FIRE SAFETY INSPECTION REPORT

REGENCY GARMENTS LIMITED

ACCORD ID: 11878

April 4, 2015

F-8 Fire Rated Construction

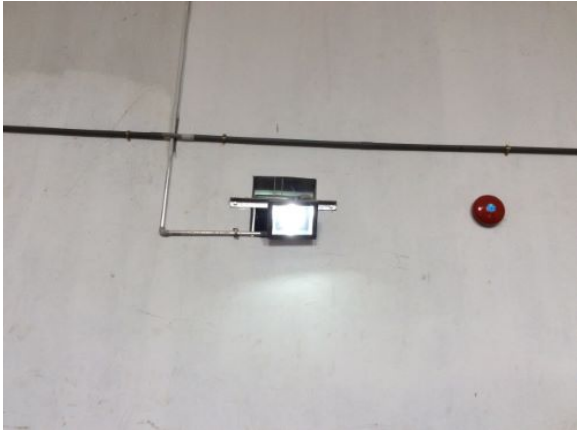
The EMR room is not separated by fire-rated construction due to openings and non-rated doors on the fifth floor. The compressor room is not separated by fire-rated construction due to penetrations on the ground floor.

Separate the EMR and compressor room by a minimum 1-hr fire-rated construction for non-high rise. Seal and protect all openings to maintain the required fire separations. When located to the exterior of a building, 3m (10 ft.) separation is required. Provide proper ventilation and consult a qualified engineer.

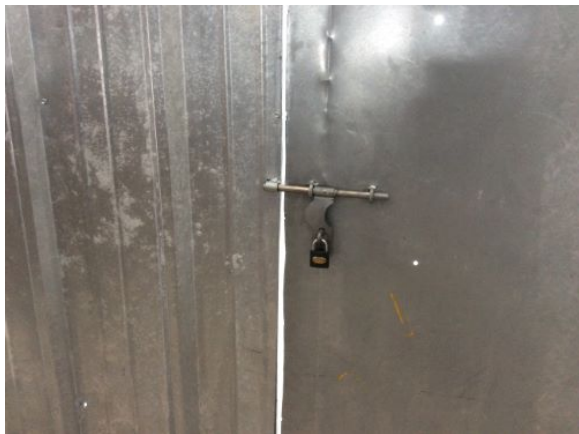
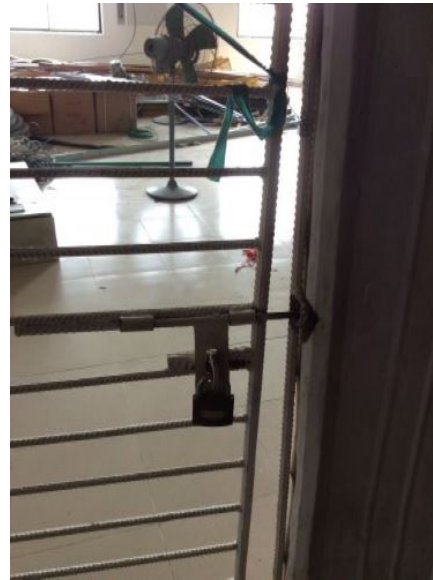
F-14	Egress	Egress doors with locking features are provided along egress routes and exit discharge. All doors were not open and unlocked during the inspection.	Remove locking features from all egress doors and gates. If locks are required for security reasons, utilize special door locking features complying with NFPA 101 and ACCORD standard 6.8.2.	Immediately
------	--------	-----------------------------------------------------------------------------------------------------------------------------------------------------	------------------------------------------------------------------------------------------------------------------------------------------------------------------------------------------------------	-------------

F-17 Egress

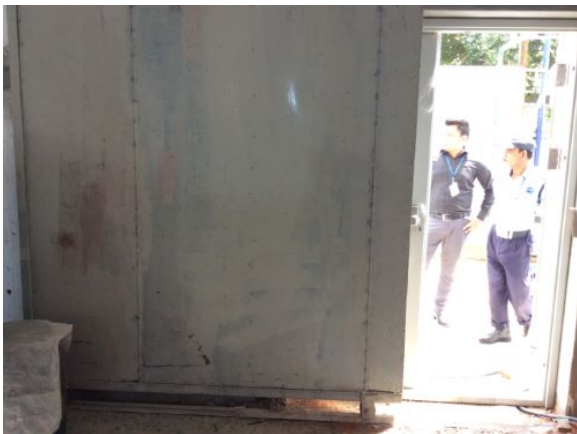
Sliding doors are provided at building exits and exit discharge.

Replace all sliding doors along the means of egress with side-hinged, swinging egress doors in accordance with ACCORD standard 6.8.1.

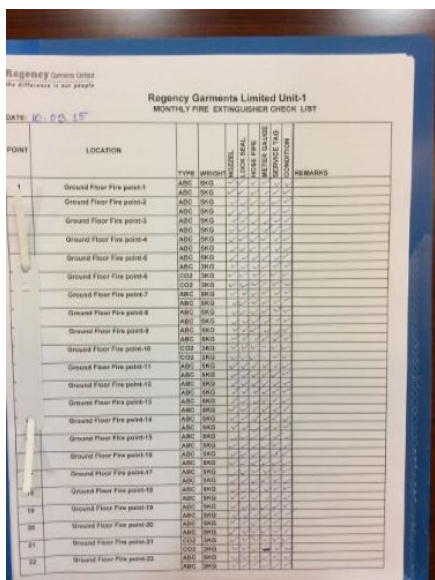
F-25	Fire Protection	Inspection, testing and maintenance of portable fire extinguishers is not in accordance with NFPA 10.	Inspect, test and maintain the portable fire extinguishers and keep written records on-site, in accordance with NFPA 10.	Within 3 months
------	-----------------	-------------------------------------------------------------------------------------------------------	--------------------------------------------------------------------------------------------------------------------------	-----------------

F-34 Egress Lighting

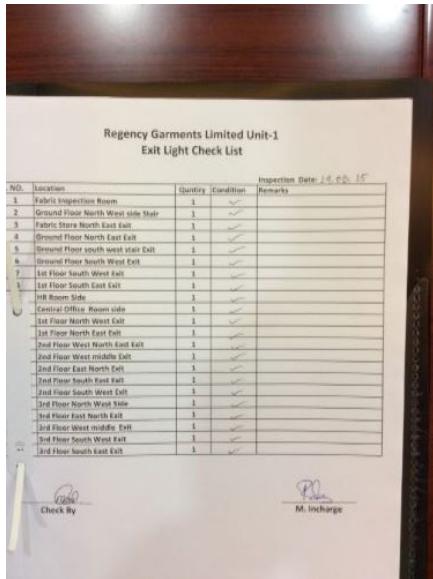
Inspection, testing and maintenance for the emergency lighting system was not in accordance with The ACCORD standard.

Inspect, test and maintain the emergency lighting system in the accordance with The ACCORD standard. Keep written records on-site.
